***Partial Revisions to the Application Document for
Approval to Amend the Implementation Plan
Regarding the Handling of ALPS Treated Water
[Overview]**

July 15, 2022

Tokyo Electric Power Company Holdings, Inc.

2-4. ALPS Treated Water Dilution and Discharge Facility (Dilution Facility)

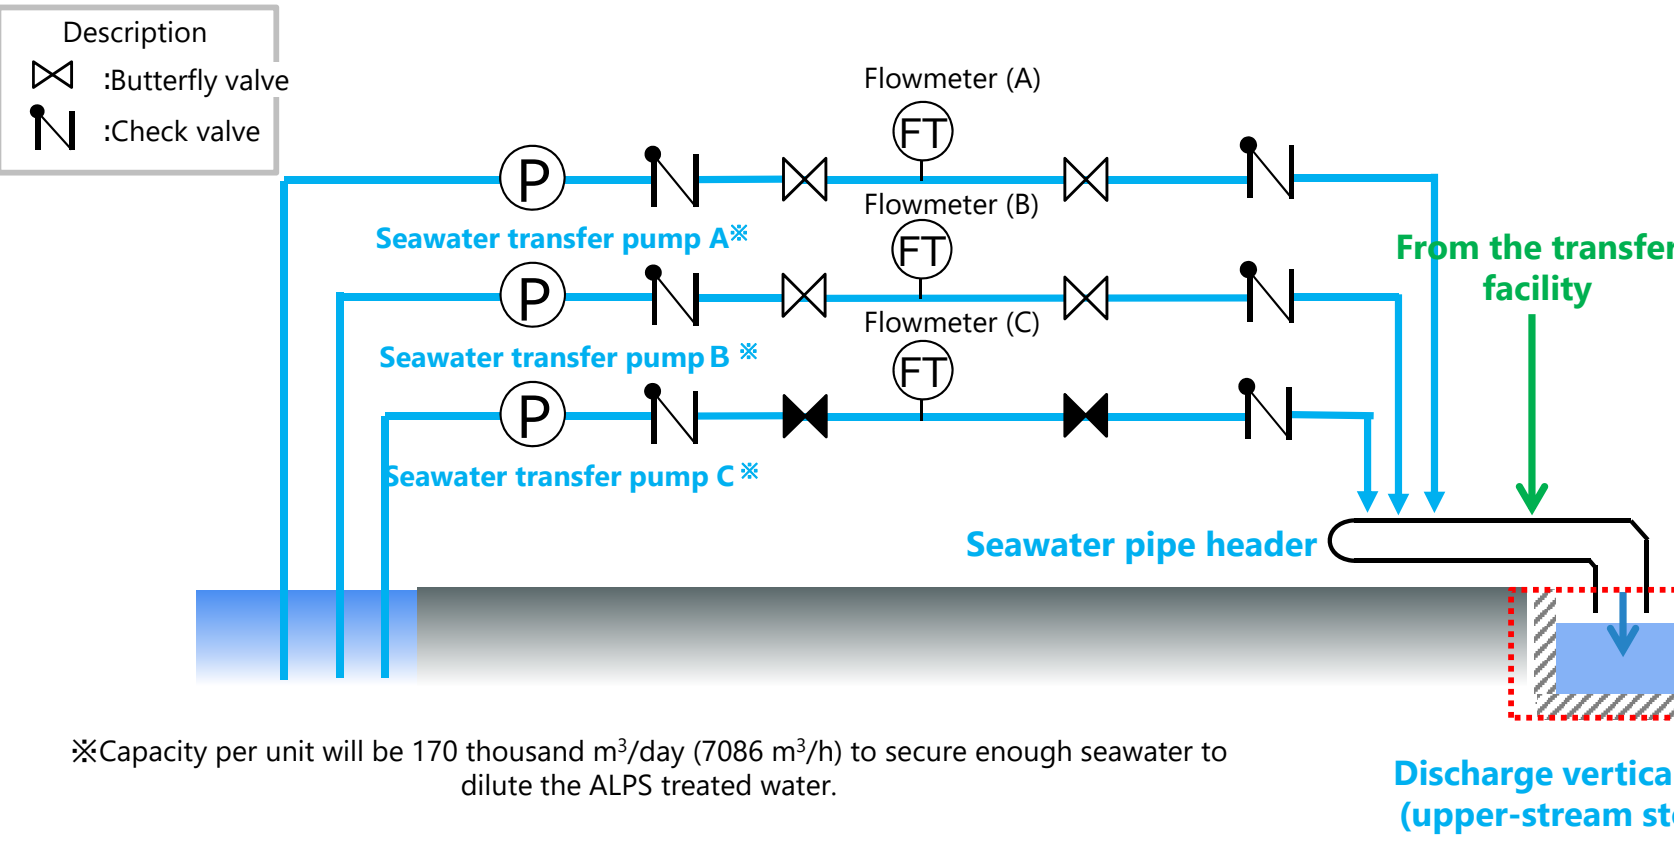
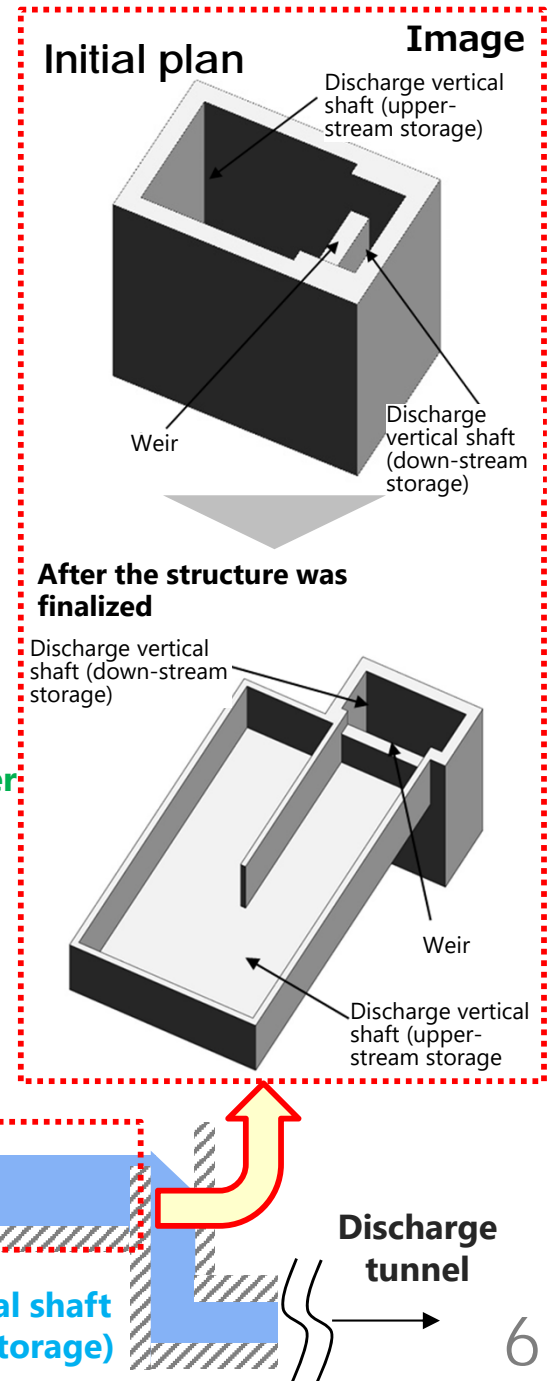
- The dilution facility is comprised of the seawater transfer pump, seawater pipe (including seawater pipe header), and discharge vertical shaft (upper-stream storage). It will dilute ALPS treated water using seawater and then transfer the diluted water to the discharge vertical shaft (upper-stream storage), and to the discharge facility.
- The seawater transfer pump will have a capacity that allows ALPS treated water transferred using the transfer facility to be diluted by more than 100 times.
- The construction of the discharge vertical shaft (upper-stream storage) was changed to a wide and shallow structure to secure safety in construction and maintainability.

4-1. Major Changes and additions

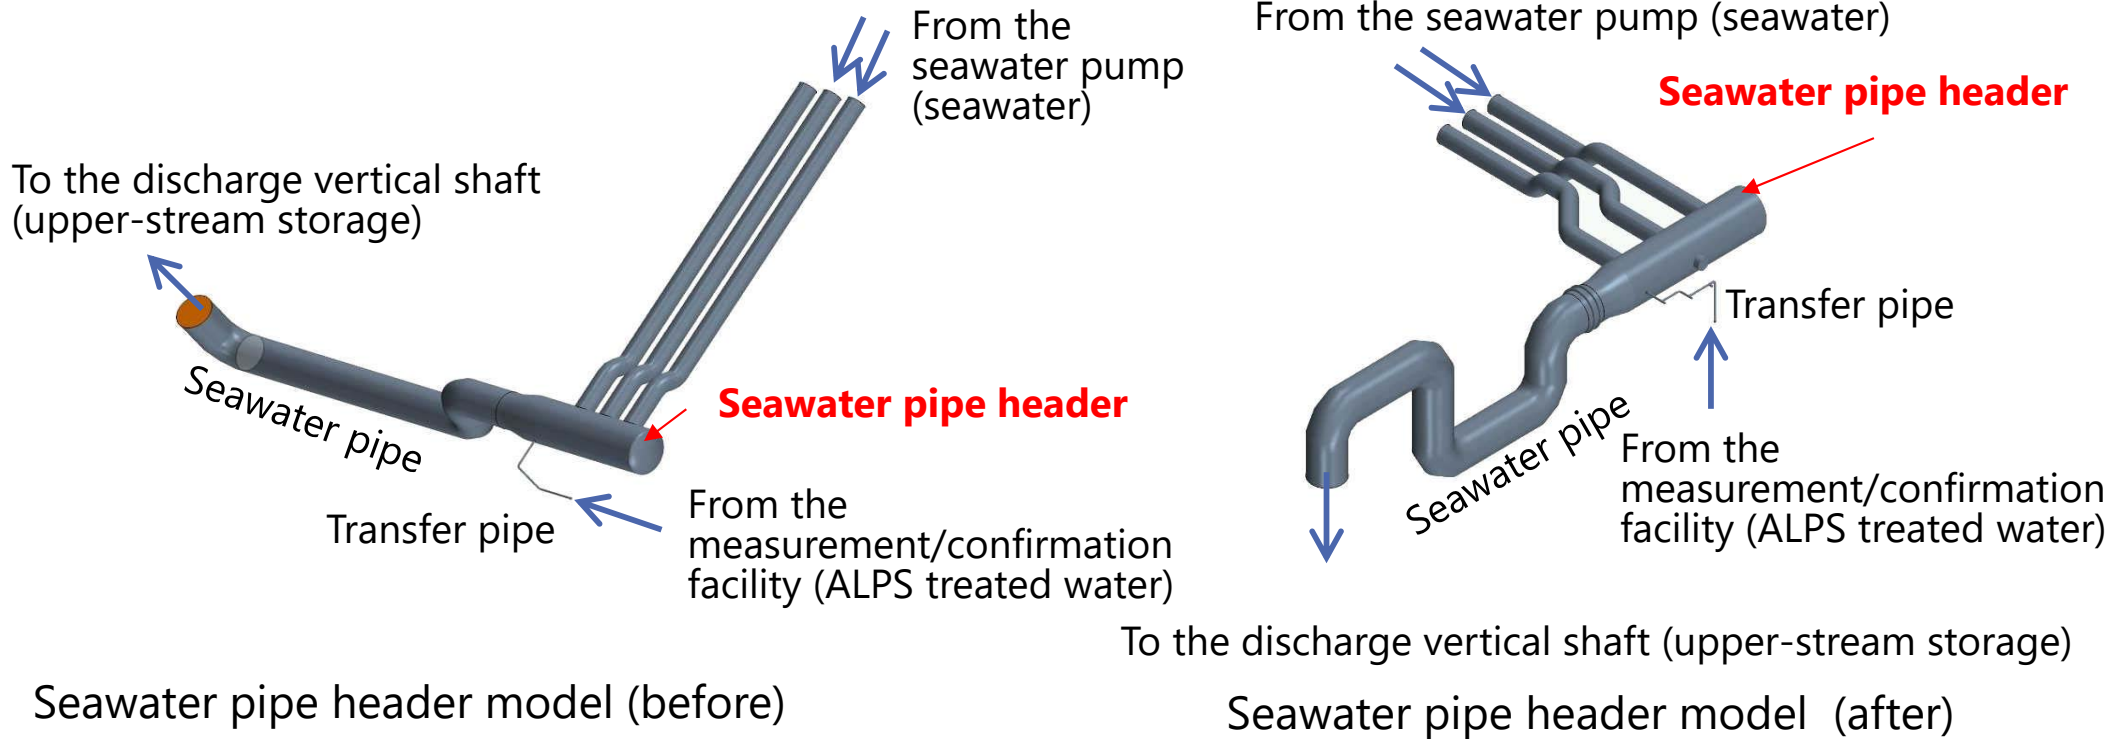
- As the structural design of the discharge vertical shaft (upper-stream storage) was finalized, the shape of the seawater pipe was also altered. The mixing and dilution assessment using the analysis code was updated accordingly. As before the design changed, it was confirmed that water could be diluted by 100 times in the seawater pipes.

- Seawater intake method / discharge method of ALPS treated water after dilution
 - A partition weir will be installed to separate the Unit 5 and 6 open conduit from the station harbor on the side of the Units 1-4 open conduit intake, and parts of the north breakwater permeation prevention works on the north side will be modified (partly removed) to create a partition for taking seawater for dilution from outside of the station harbor on the north side of the Units 5 and 6 discharge outlet. This will reduce the amount of seawater with relatively high radioactive materials concentration flowing in from the side of the Units 1-4 open conduit intake channel (See diagram in slide 8).

4-2. Major Changes and additions

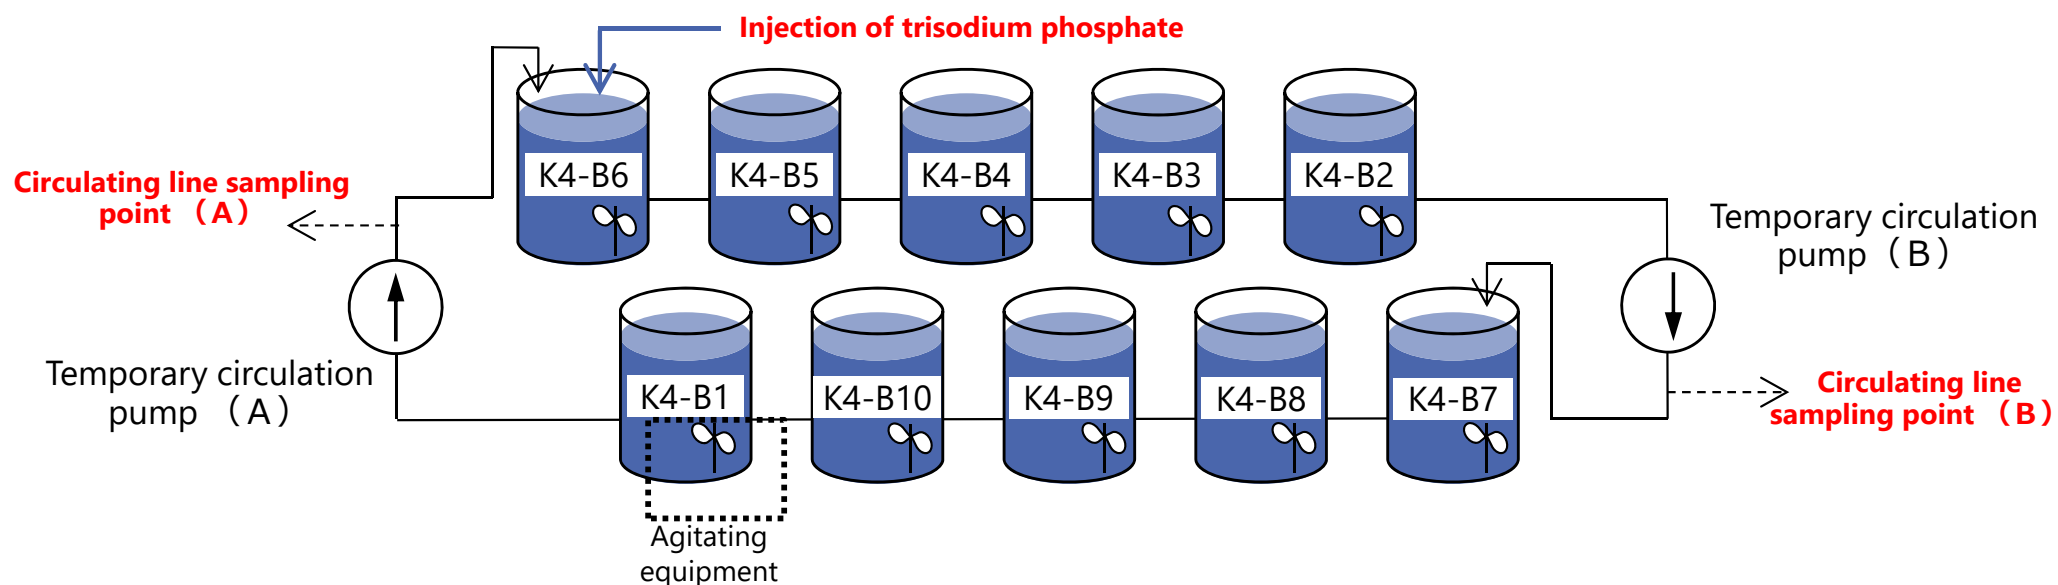
- To ensure the radioactive concentration of ALPS treated water before discharge into the sea can be made homogenized, a agitating demonstration test for one tank with trisodium phosphate as the reagent was conducted in November 2021. While A circulation agitating demonstration test connecting 10 tanks (see diagram below) was conducted in February 2022. These tests confirmed that the concentrations can be made homogenized with this equipment configuration for 10 tanks.
- The application was amended to include that based on these results, the actual equipment configuration will be set up similarly to the demonstration test and the circulation and agitating time will be set appropriately (enough for the full tank amount to circulate the 10 tanks twice at the start of operation).

4-3. Major Changes and additions

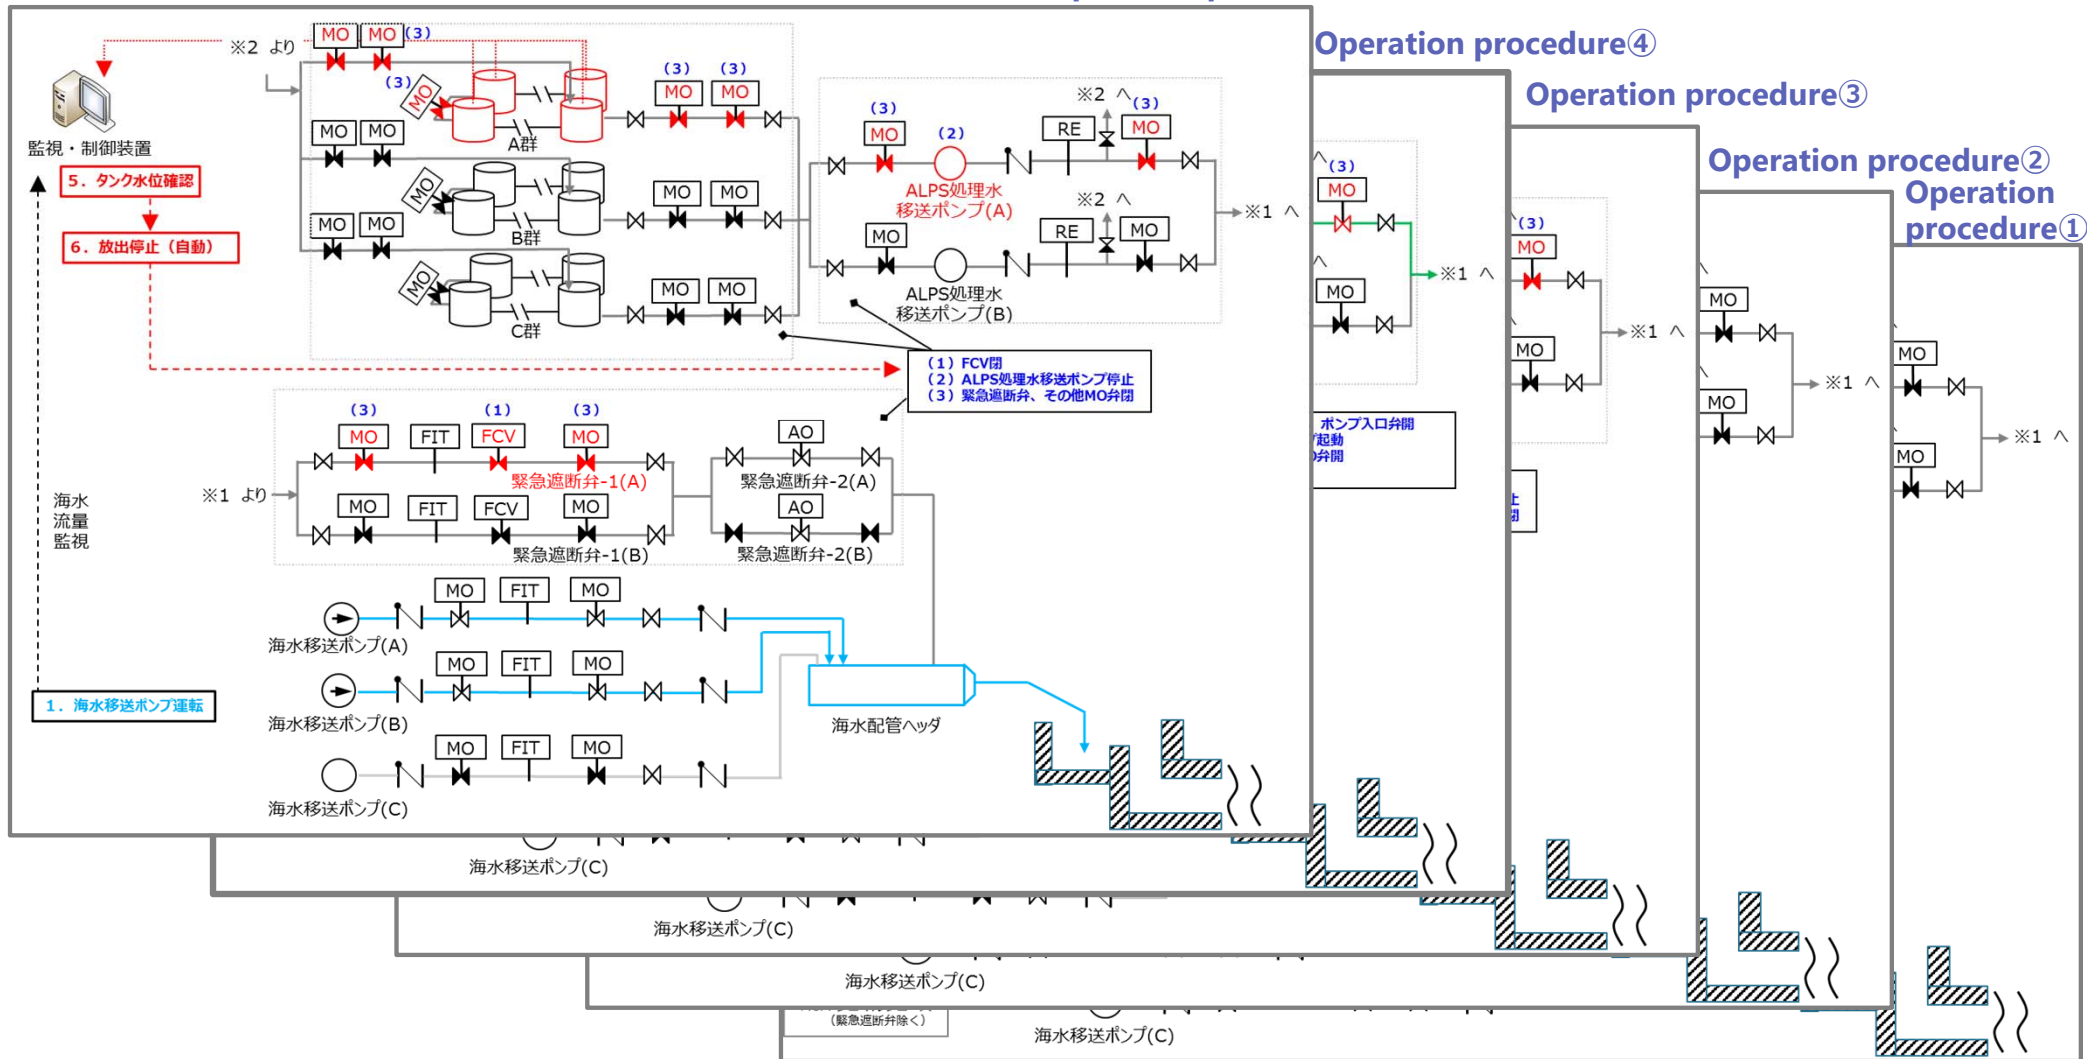
- Operation management for ALPS treated water dilution and discharge facility
 - Added the operation procedures for the measuring and confirmation step and the discharge step in the ALPS treated water dilution and discharge facility , and the appropriateness of design and operation of the ALPS treated water dilution and discharge facility.

4-4. Major Changes and additions

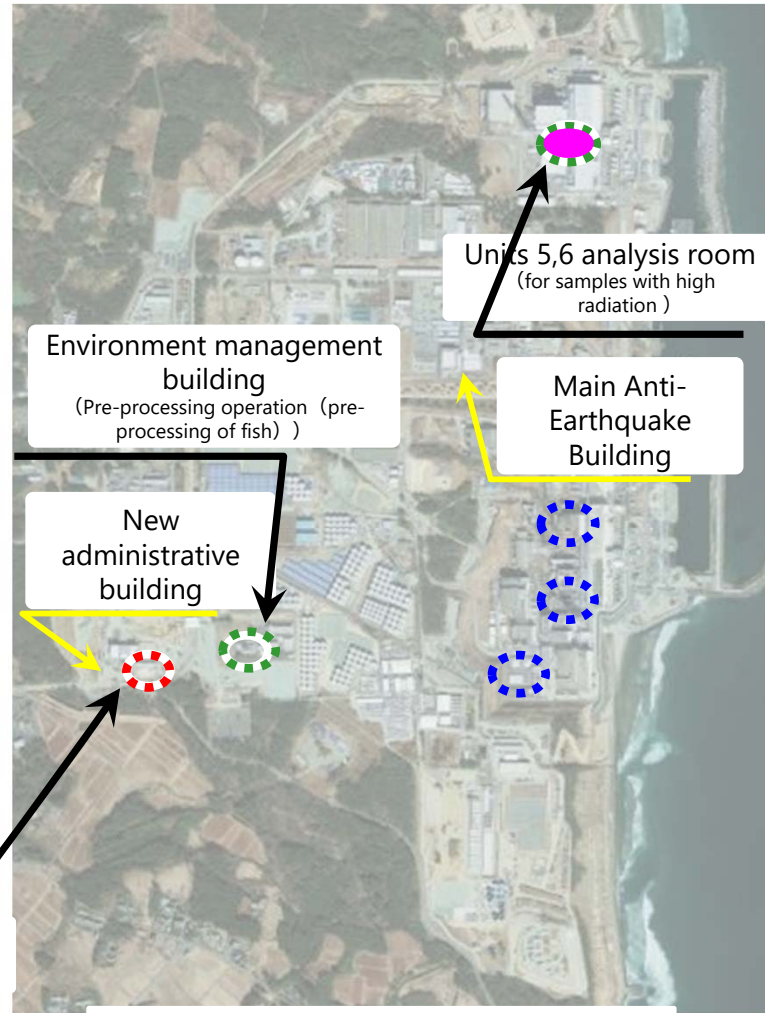
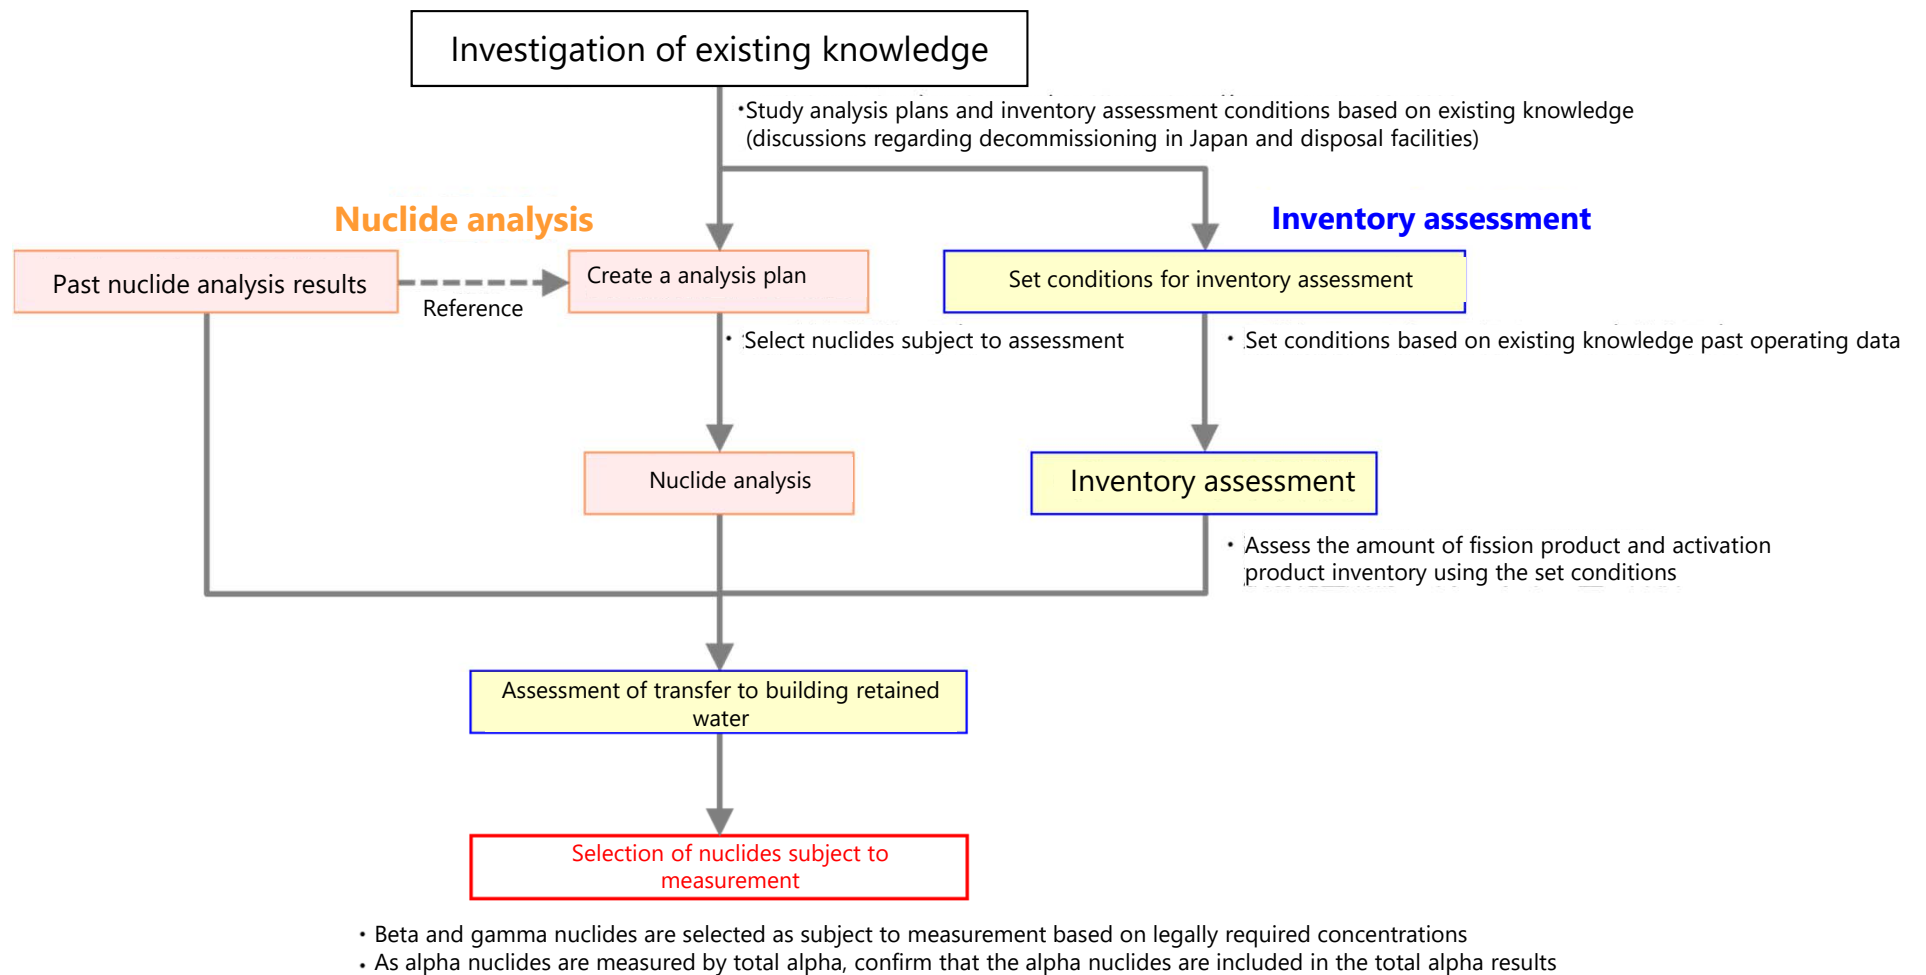
- ALPS treated water analysis methods, structure
 - Clarified the resources necessary for analysis (analysis devices, personnel, etc.) and the structures necessary to perform the analysis, analysis methods and matters to be implemented to secure objectivity and capability.
